PUR-1378
ADDENDUM NO. 2
INVITATION TO BID

THE MARYLAND THEATRE EXPANSION
IN HAGERSOWN, MARYLAND

DATE: Monday, March 26, 2018

A18 EAST ELEVATION
1/4" = 1'-0"

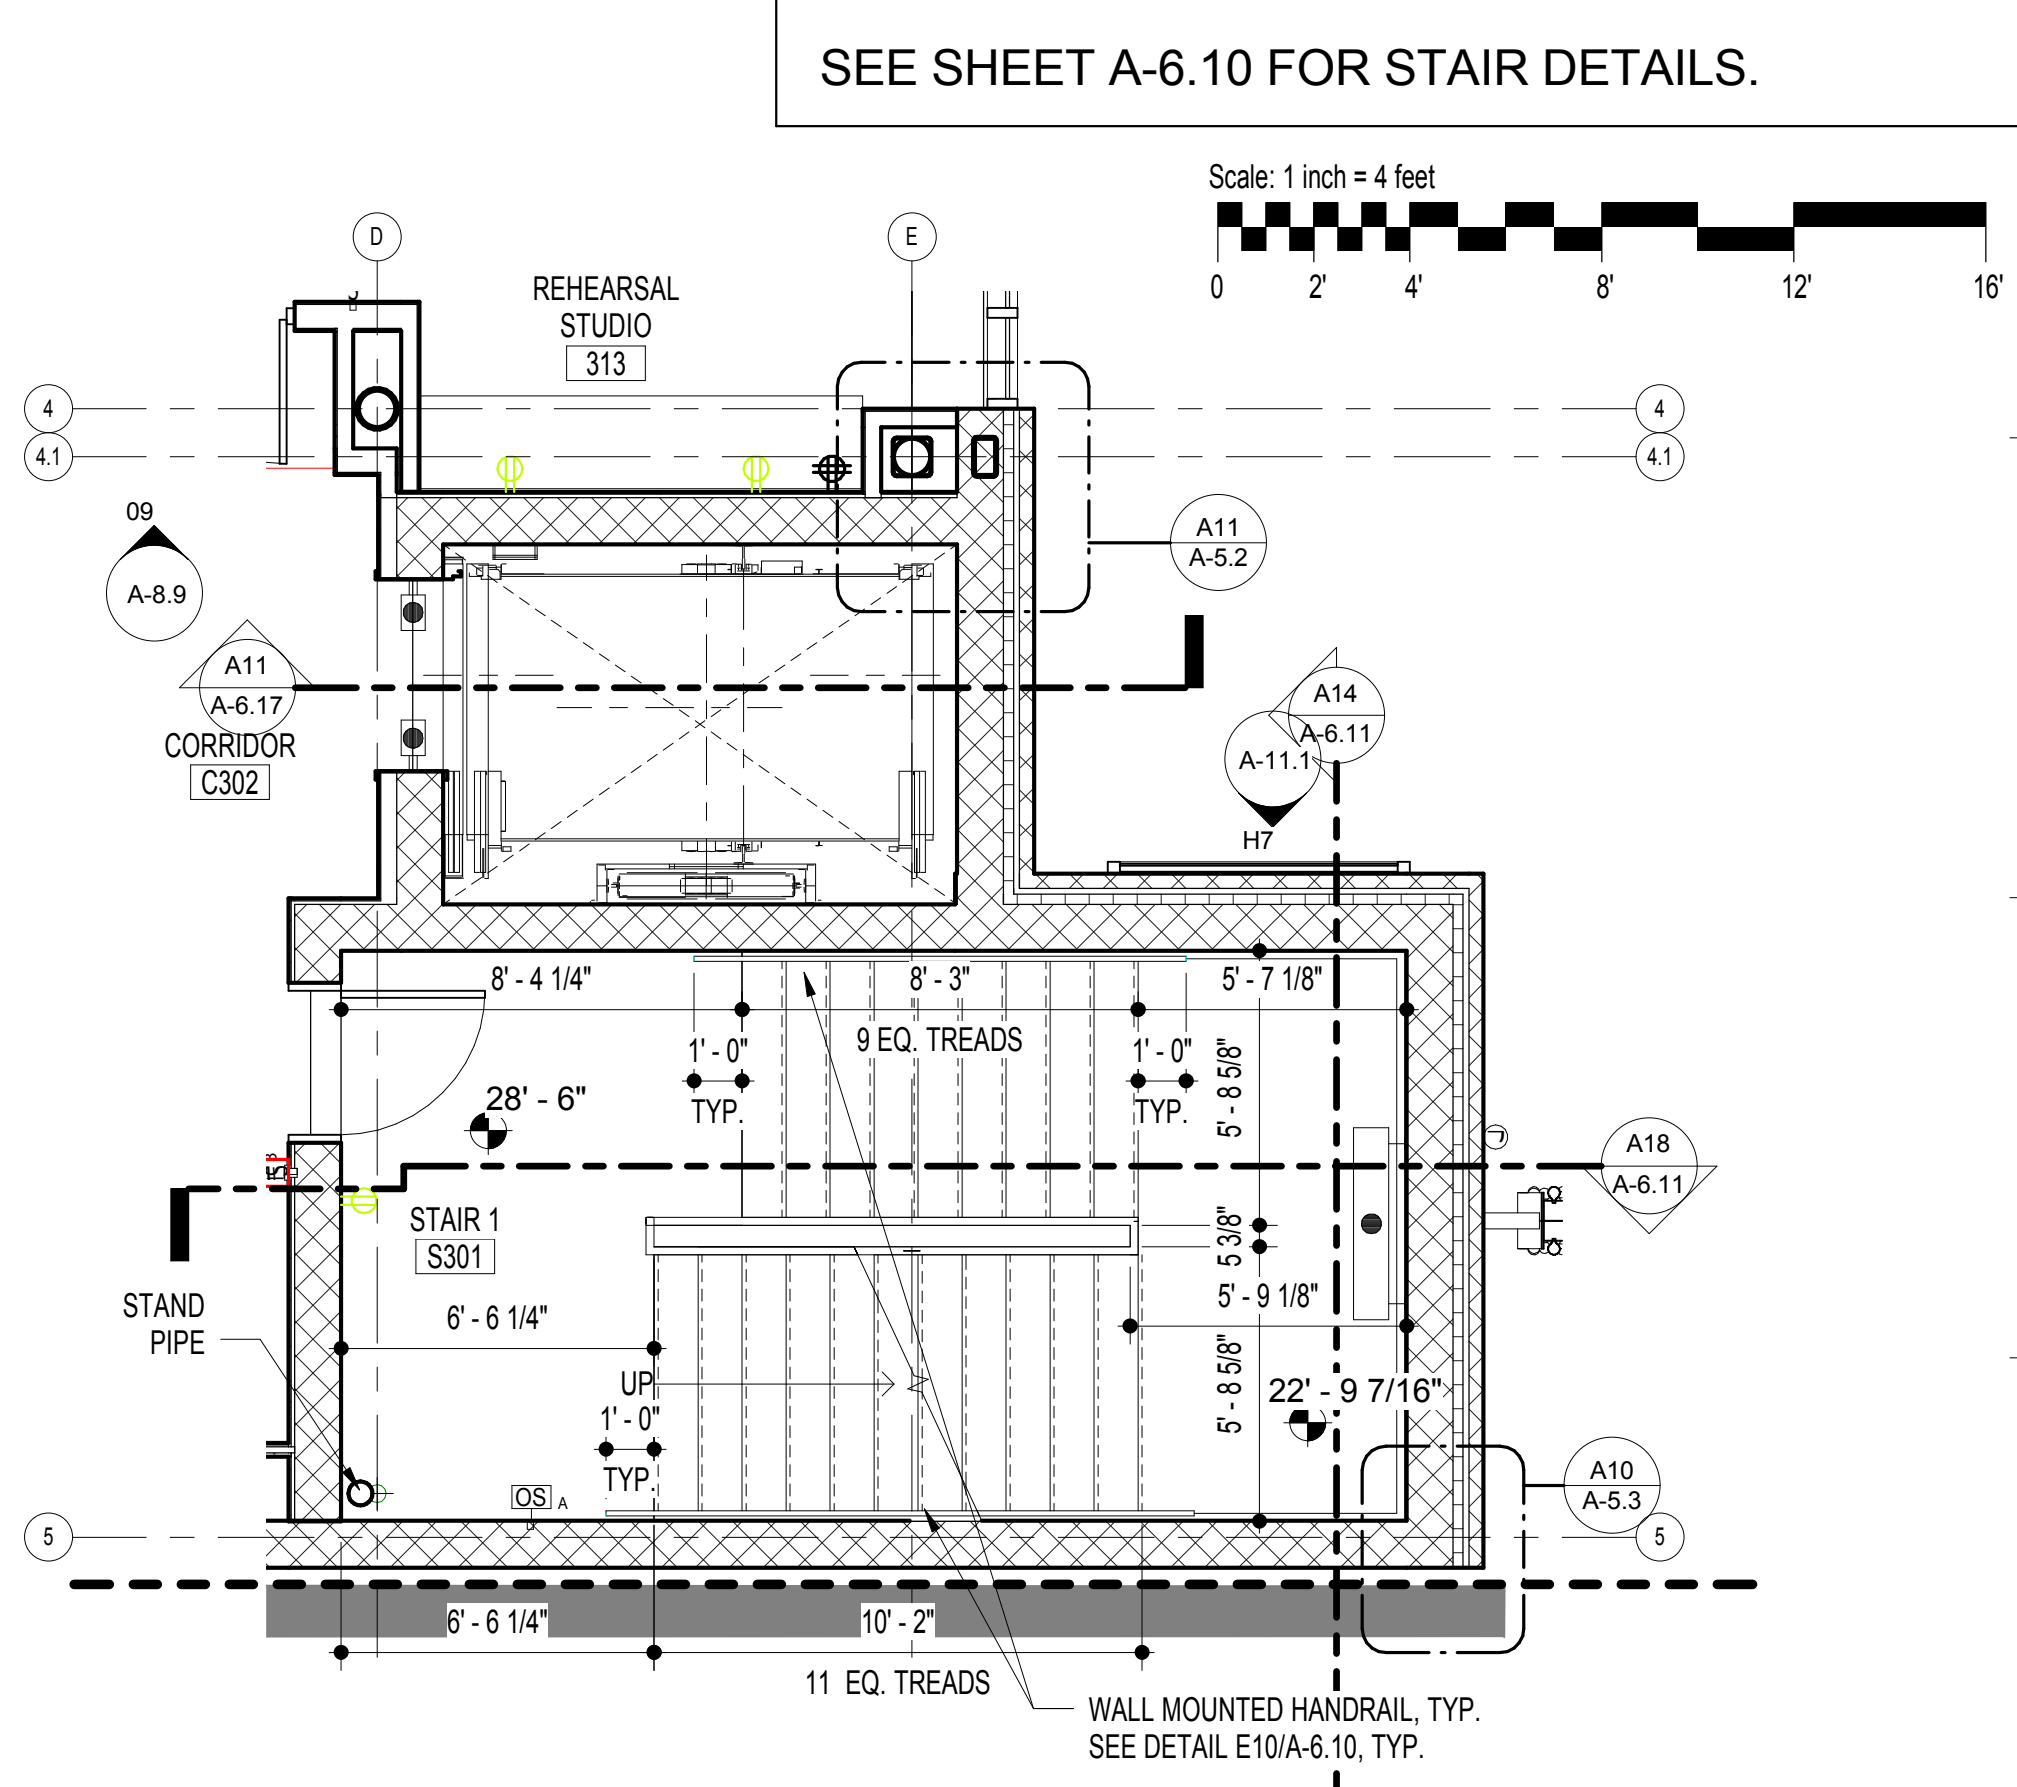
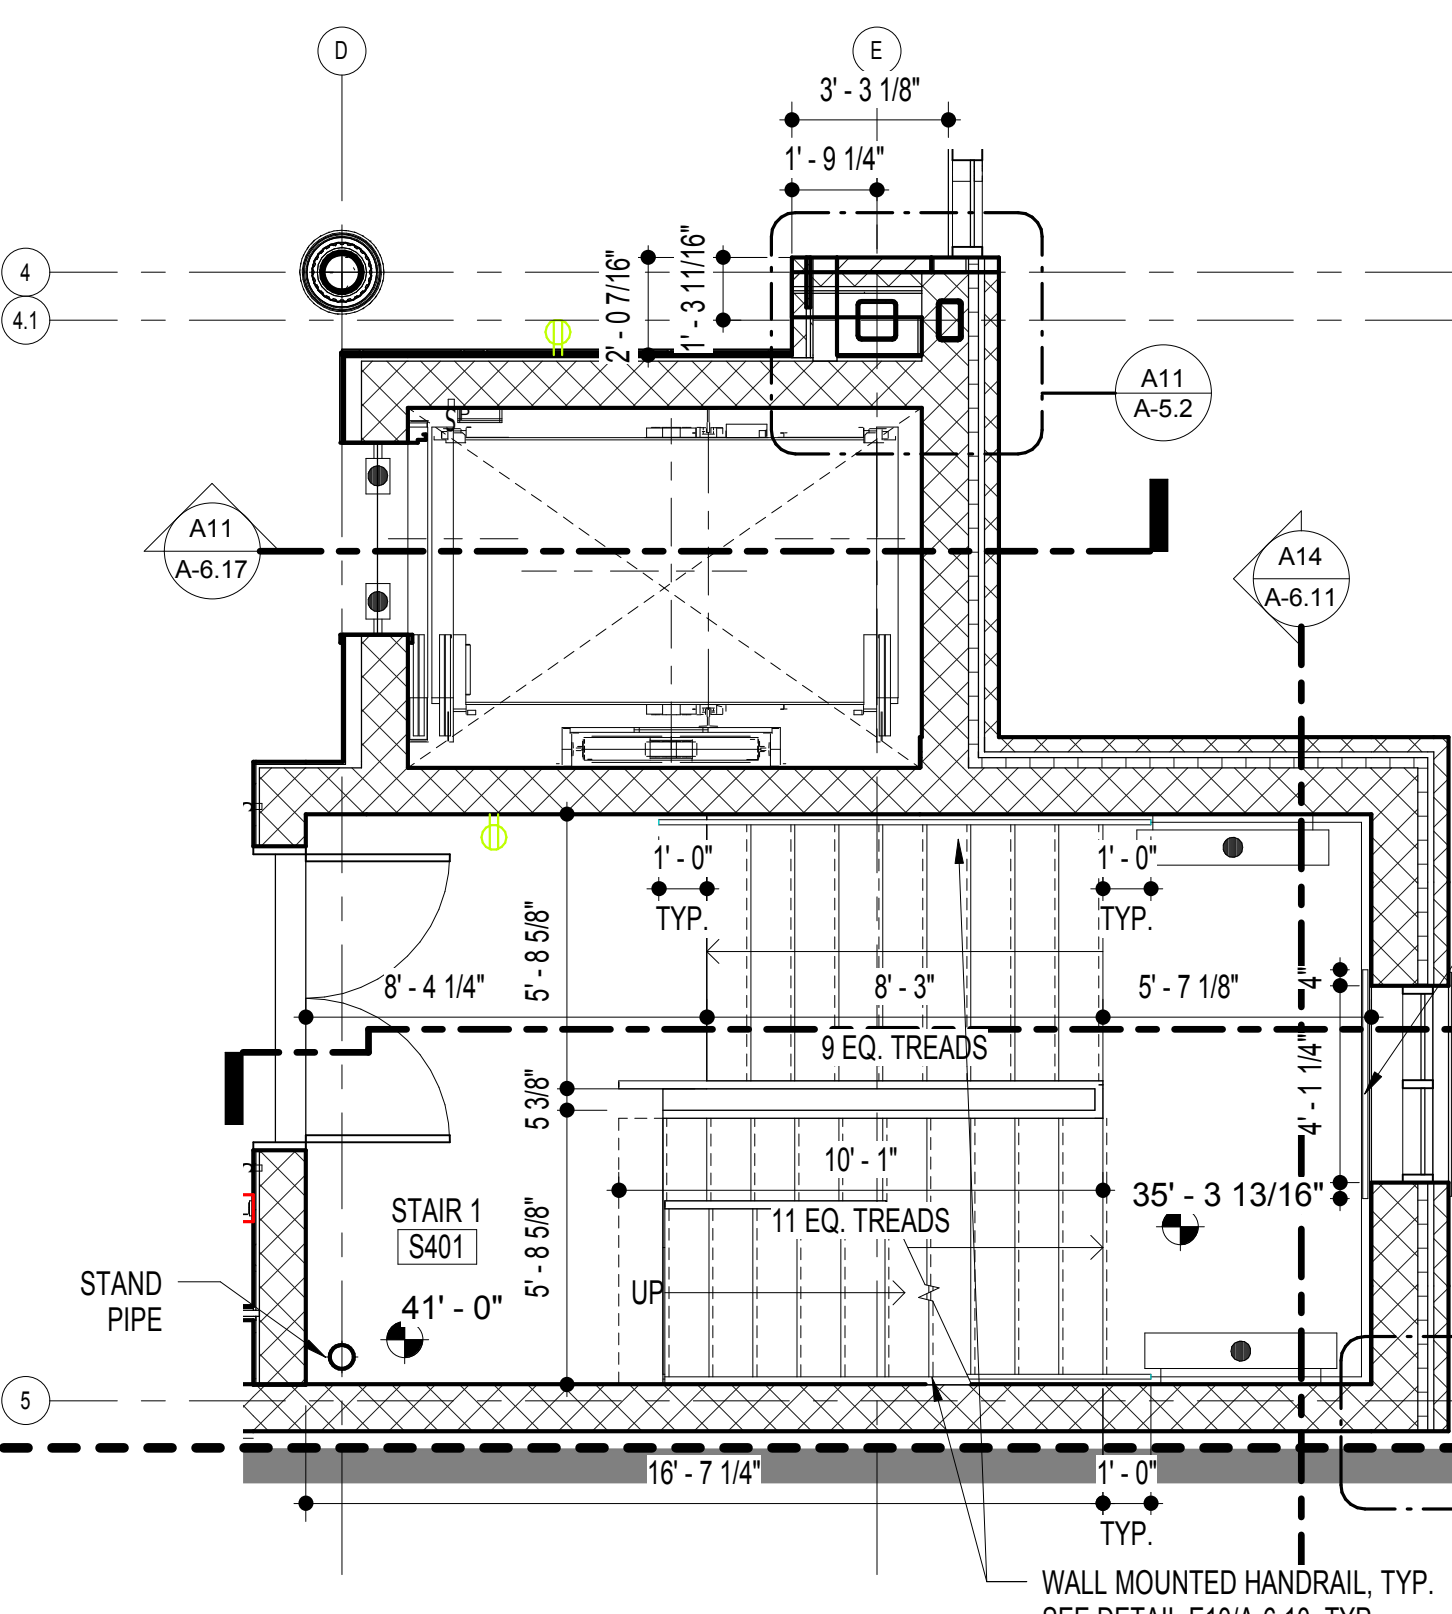
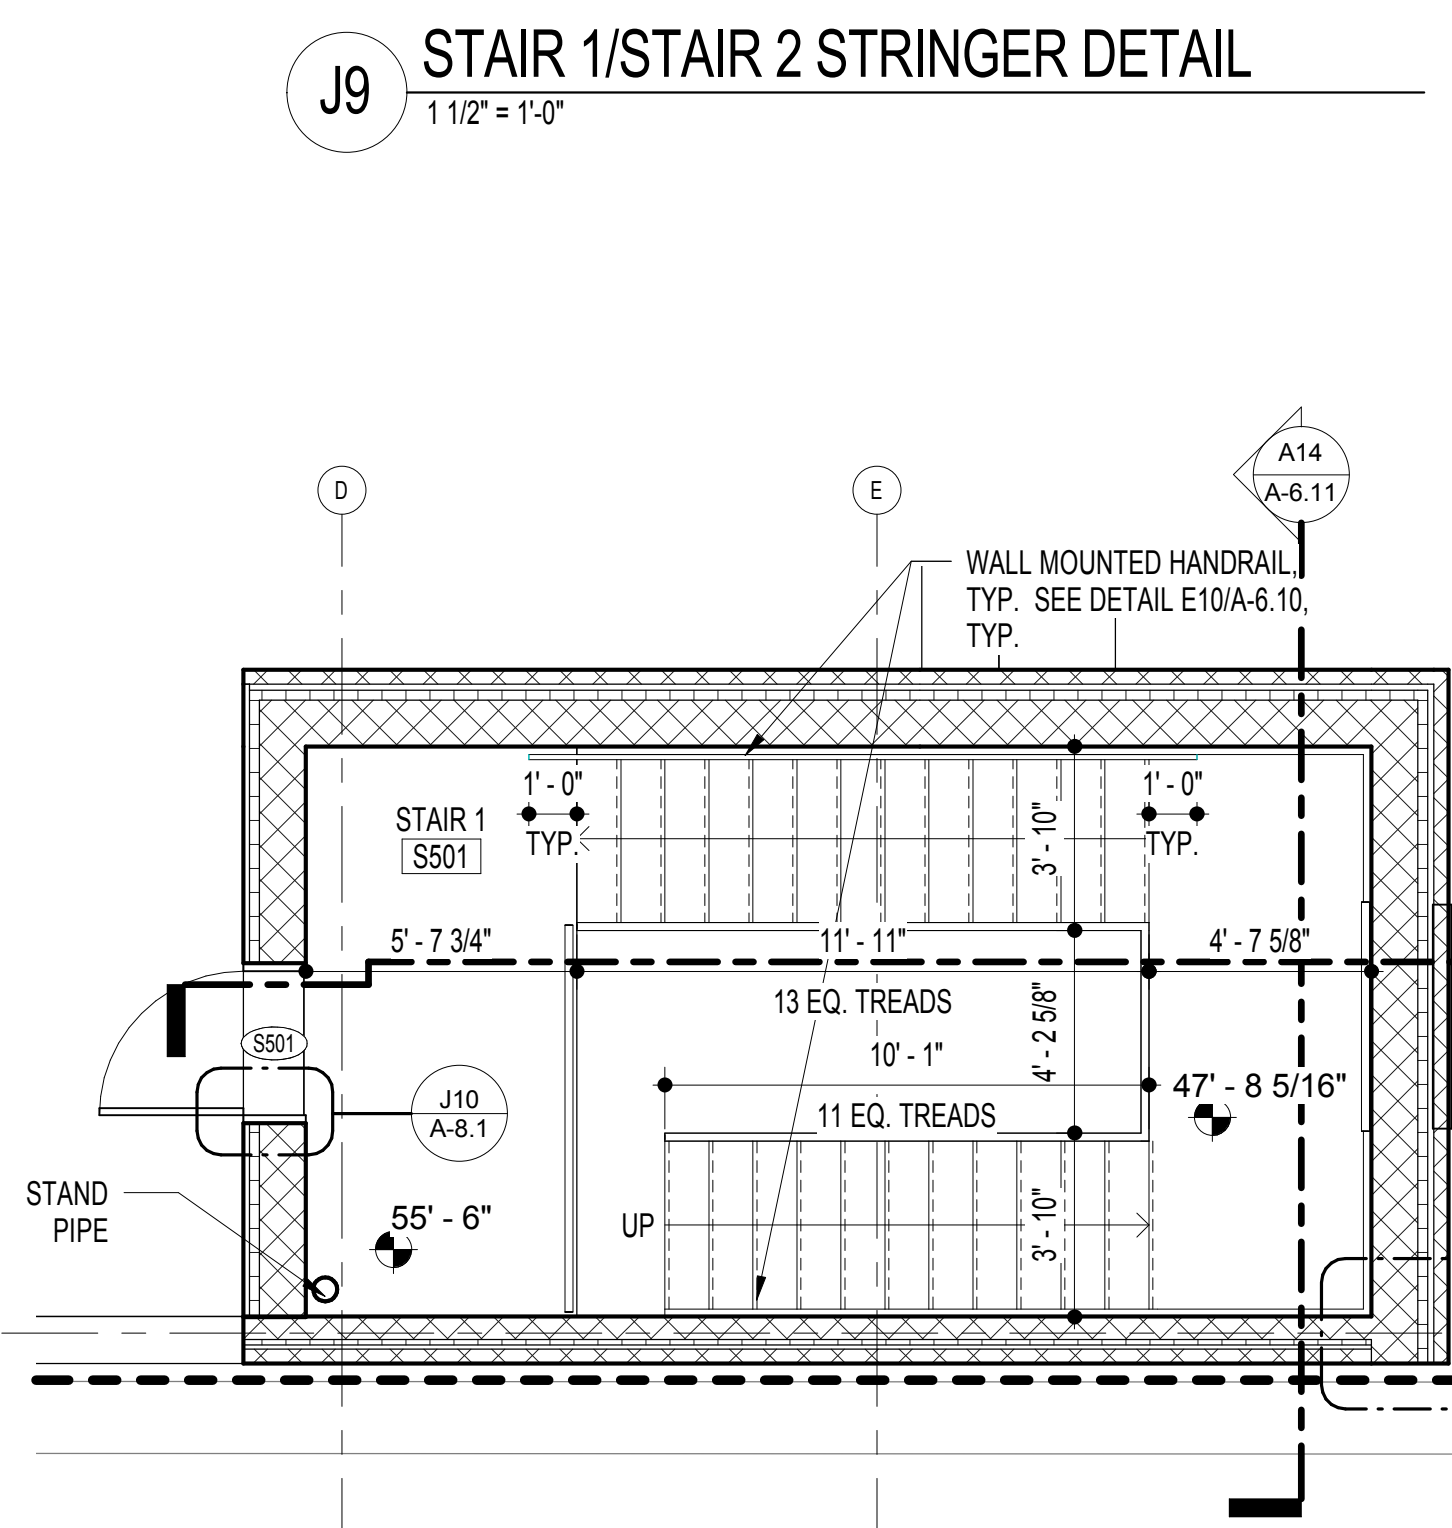
- ITEM NO. 99** SHEET A-3.1 – EXTERIOR ELEVATIONS *(SHEET ATTACHED)*
- REVISE** Revise height of Doors EXS101B, EXS101A and EX100 per sidewalk elevations
